# Three Oaks Mine

## Final Environmental Impact Statement Volume I

**FINAL  
ENVIRONMENTAL IMPACT STATEMENT  
THREE OAKS MINE**

This Final EIS has been prepared in an abbreviated format; the Final EIS must be used in conjunction with the Draft EIS, which was issued August 23, 2002. The Draft EIS and Final EIS together comprise the complete EIS. The Final EIS is organized as follows: The Summary is reprinted in its entirety. Following the table of contents, text and appendix pages with revisions are reprinted in the Final EIS. Additions and changes to the Draft EIS are indicated in ***bold italics***; deletions are indicated as ~~crossed-out text~~. New Sections 4.4 and 4.5 describe the public comment period and provide responses to general public comments, respectively. Two new appendices, G and H, are included in the Final EIS. Appendix G comprises the U.S. Fish and Wildlife Service concurrence letter on potential impacts to sensitive species; the public comments received during the Draft EIS public review period and the USACE's associated responses are included in Appendix H of this Final EIS.

Figure 2-10

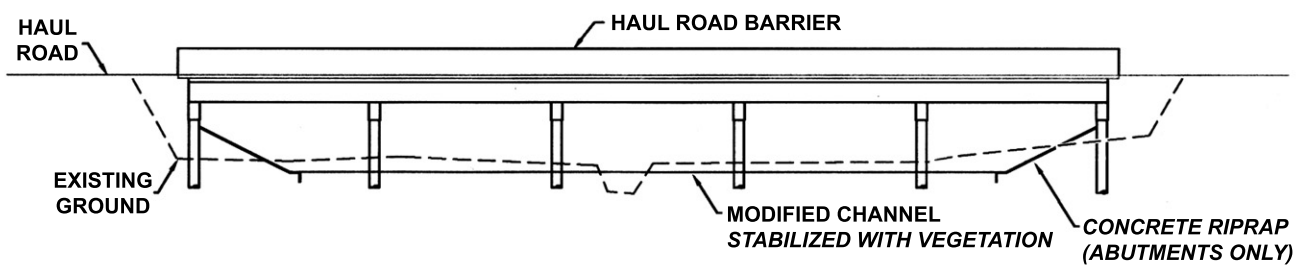
Figure revision: Revised labels relative to redesign of Middle Yegua Creek crossing.

Figure 2-14

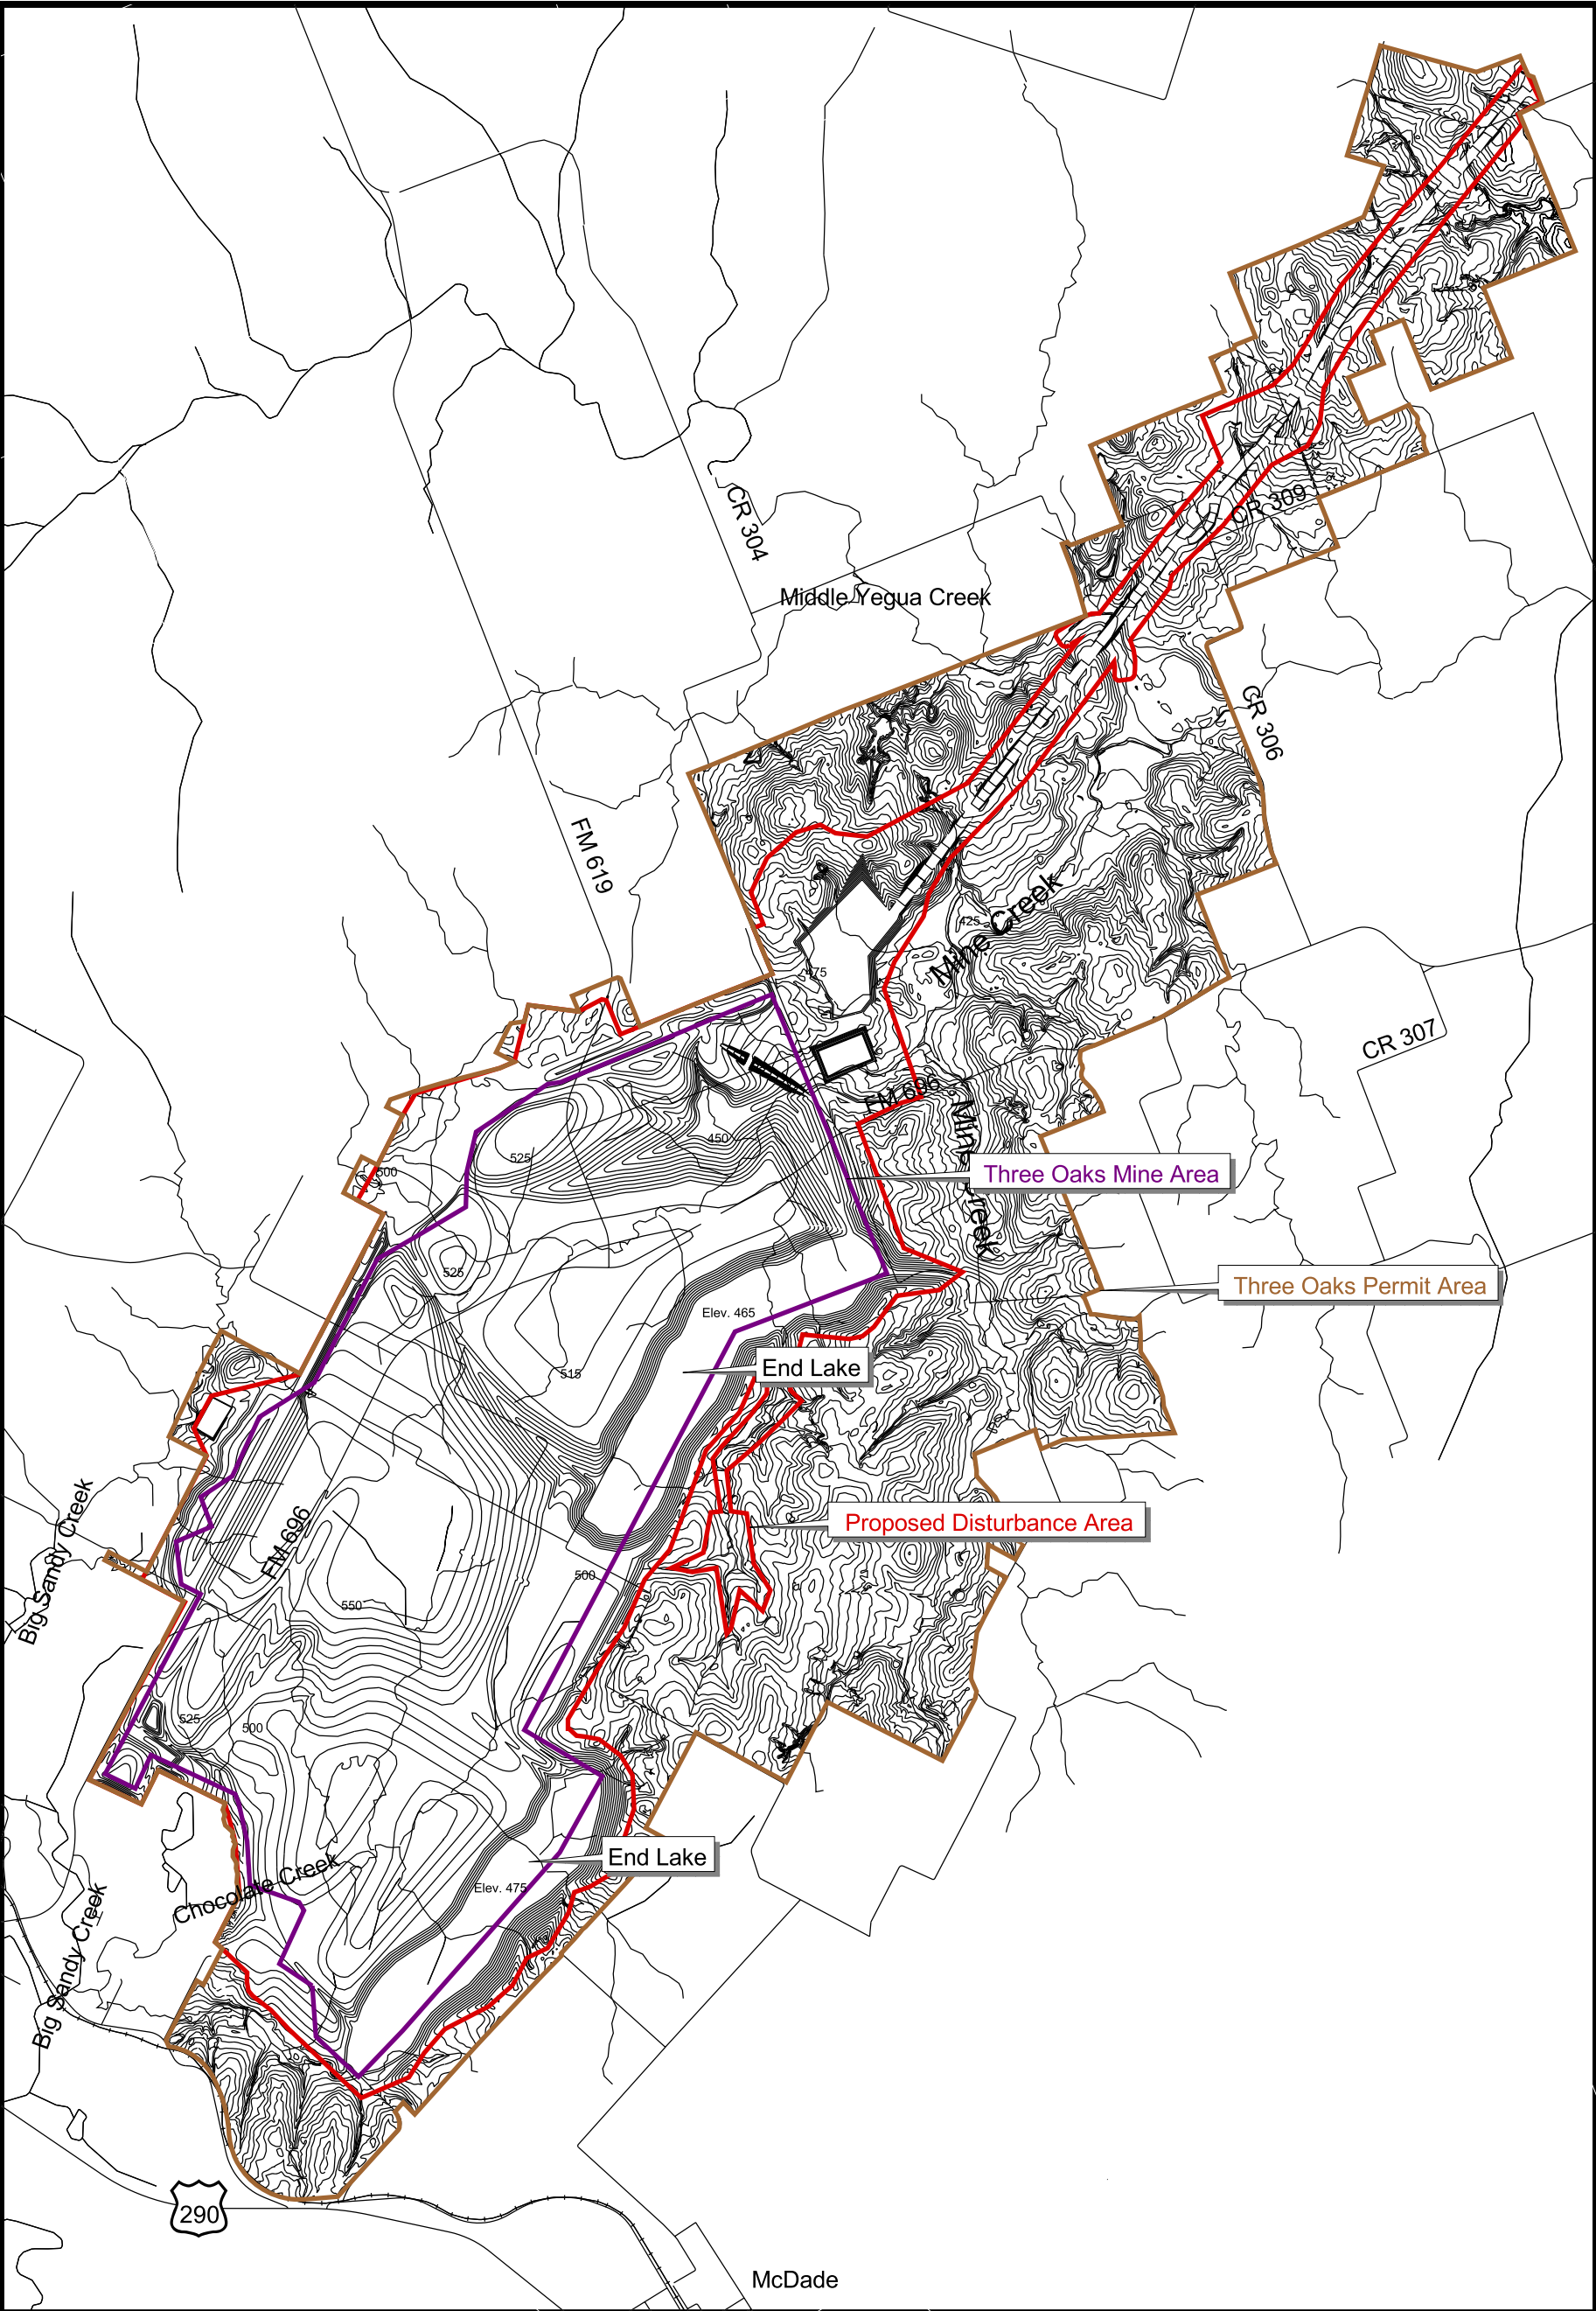
Figure revision: Revised disturbance area for transportation and utility corridor crossing of Middle Yegua Creek; added Big Sandy Mitigation Site.
